(Working Papers: 1-17p)
 "Comparative Risk and
 Analysis of Assumptions"
 Used in Comparing Models
 IEPA-CLI-TSCA
 Contam. Pathway Assmt's
 Part of 42pp discussion doc.

U.S. EPA Region 5
 Barrier Units...
 Factor of Safety Calc.
 10/16
 S.M. Johnson 9/24/08

U.S. Env. Prot. Agency R-5
Corrected
Pathway Review... Analysis
Clinton L.F. A-A'
SA. Johnson 10/16/08

U.S EPA Region 5
Table of Safety Models
Clinton L.P. #3 CWU-PCB Cell
Dewitt Co. Ill.
S.M. Johnson 1/21/08

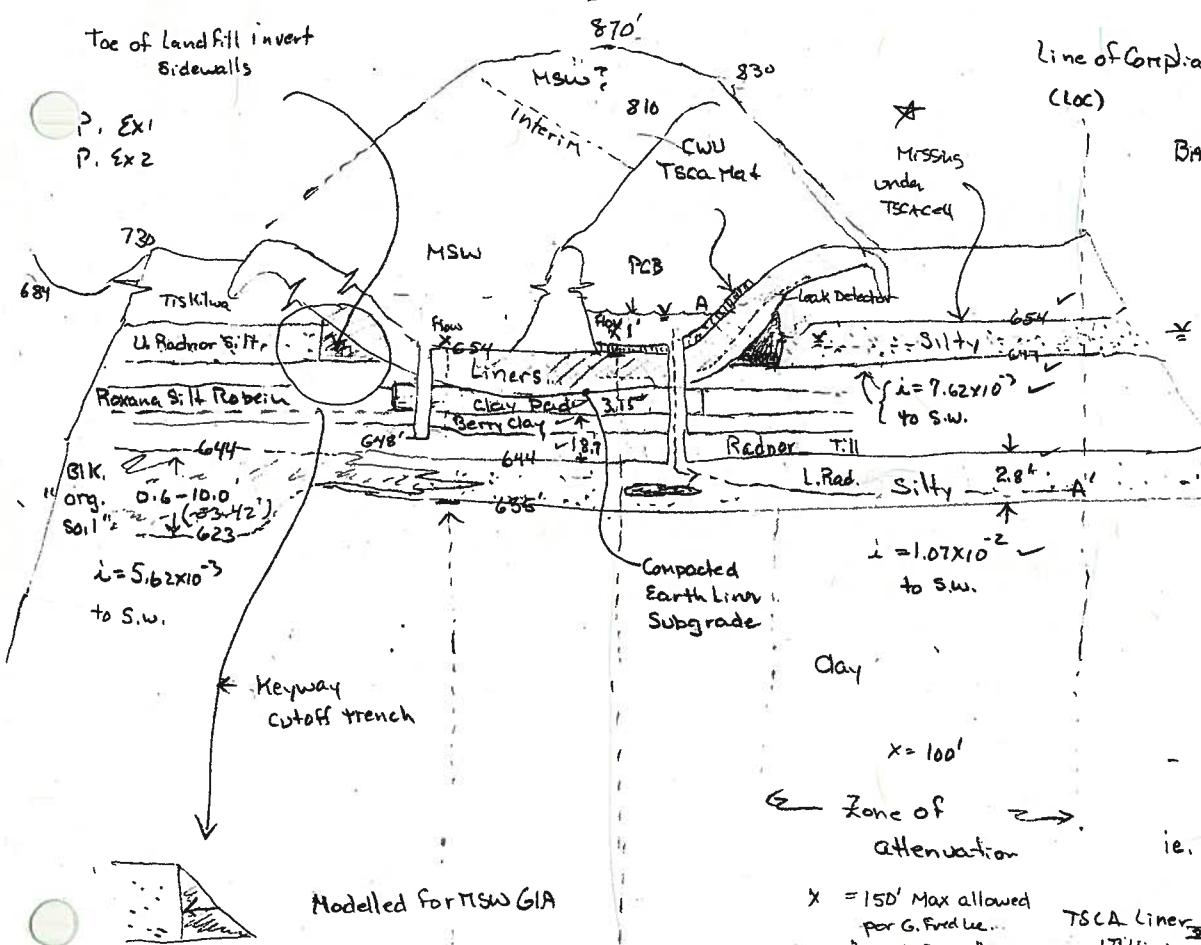
CWU Model: RB Path

- Should not ignore Liner

Cut-off Trench ignored in MSW GIA
(see path A)

U.S. Env. Prot. Agency Reg 5
Mahomet Aquifer Depth Calculations
G.M. Johnson 10/16/08

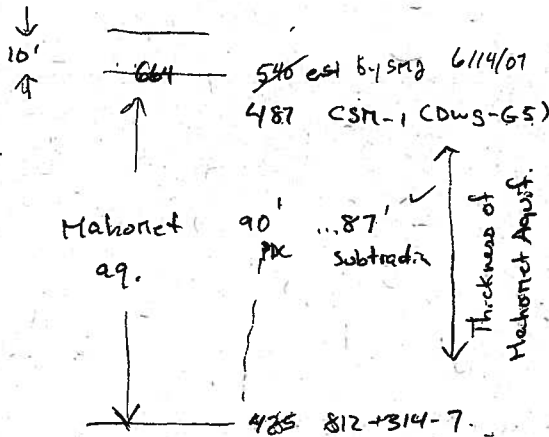
assumption
reduce volume
of aquifer
by neglecting
to increase
impact of
chemical constituents

Draft worksheet ... ok

U.S. EPA R-5	
Probability illustrations	
- Liner failure creating a release...	#9
S.M. Johnson	9/24/68

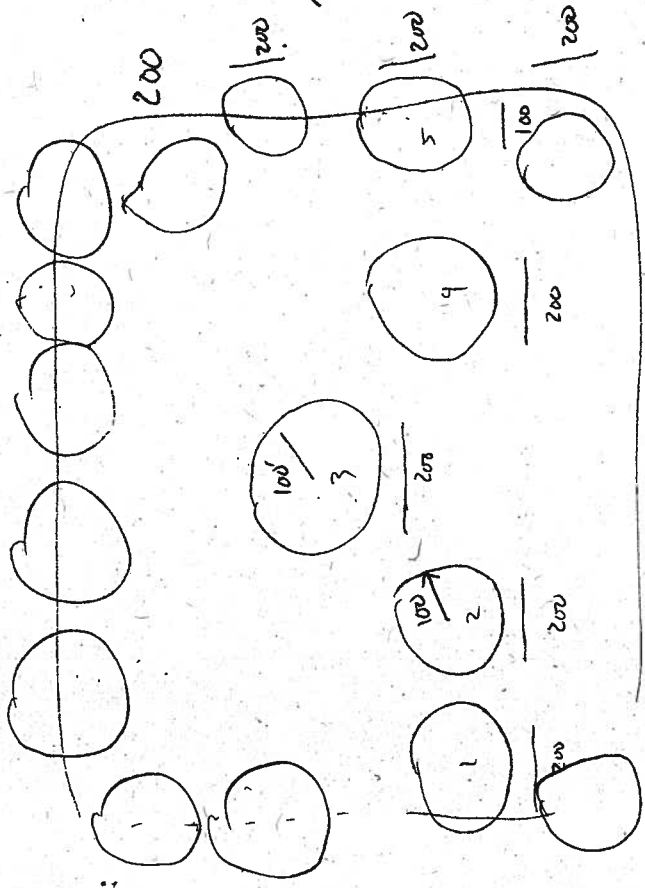
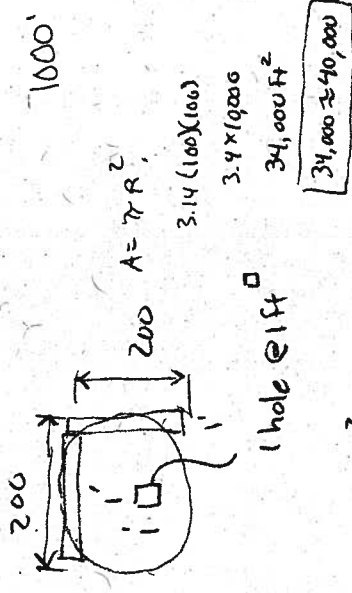
over Time... No good

Hole does not influence leakage

Ok to use Sy
